# DSOX93204A-03

## S E R V I C E N O T E

### DSOX93204A 32GHz Digitizing Oscilloscope

**Front panel connector may not offer a good ground connection for probes**

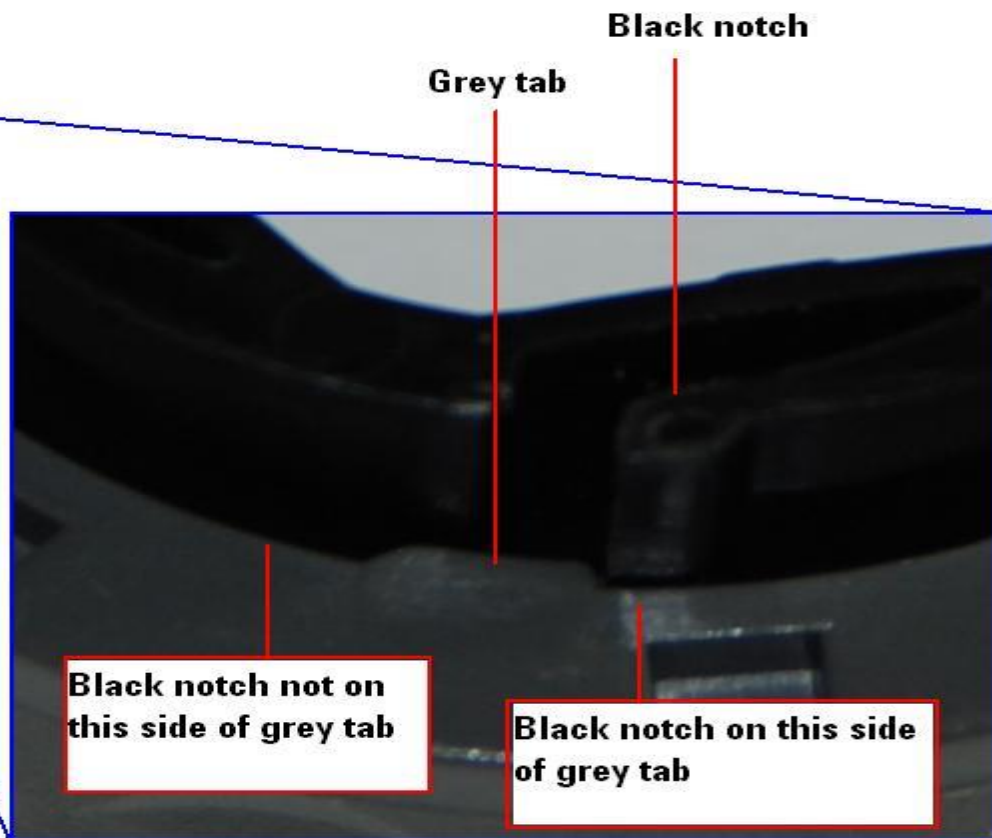
2. Put the soft strap or string behind the gray outer clutch and carefully work it around the outer clutch.
